REPORT FOR ACTION

Demolition of Three Heritage Properties in the South Rosedale Heritage Conservation District - 5, 7, and 9 Dale Avenue - Supplementary Report

Date: July 25, 2018
 To: City Council
 From: Chief Planner and Executive Director, City Planning
 Wards: Ward 27 – Toronto Centre-Rosedale

Attachment 3: Revised Proposal - Site Plan

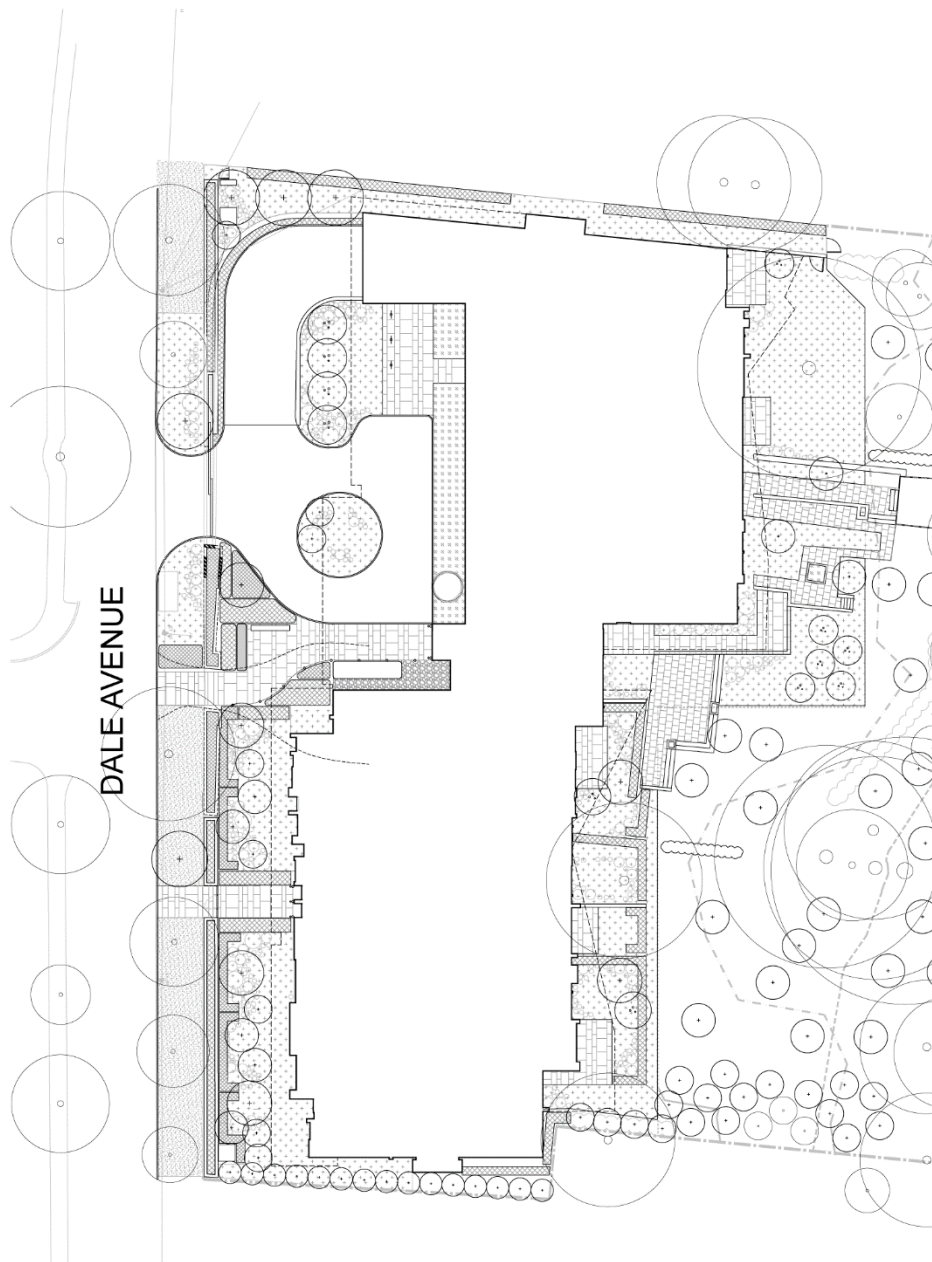
As requested by Toronto and East York Community Council, Planning staff met with the applicant and discussed the abovementioned concerns. The applicant responded with a with prejudice settlement offer (July 20, 2018) that incorporates the following revisions:

- Retaining the "tea house", planting beds and garden walls, and as much of the historic landscape and landscaping features as possible in the rear yard of 7 Dale Avenue to be used as a common outdoor amenity space, subject to the approval of TRCA and RNFP staff. Planning staff have begun discussions with the TRCA regarding these modifications;
- Retaining as much of the historic landscape and landscaping features at the front of the property as possible, such as the front yard boundary wall-planter, iron railings and gates;
- Extending the front yard planters in a form that does not replicate but responds sympathetically to the existing planters;
- Removing front yard outdoor patios and two pedestrian walkways to increase the amount of soft yard landscaping;

- Landscaping the new front and rear yards in a form that is sympathetic to the design principles of the existing landscaping;
- Reusing existing paving materials for the front entrance walkway, the emergency walkway from the west half of the building, and rear terraces;

- Increasing the west side yard setback for the front portion of the building to a minimum of 2.5 metres to allow sufficient space for 6 inch caliper, 25 foot tall beech trees to be planted along the west side wall;

- Continuing the west side yard beech trees into the front yard to further screen the building from the public realm;
- Removing balcony encroachments into the 3.6-metre gap between the two halves of the building to increase visual permeability into the ravine; and

- Decreasing the depth of the 1-storey portion of the building connecting the two halves of the building and making the north and south walls fully transparent to further enhance the visual permeability into the ravine.
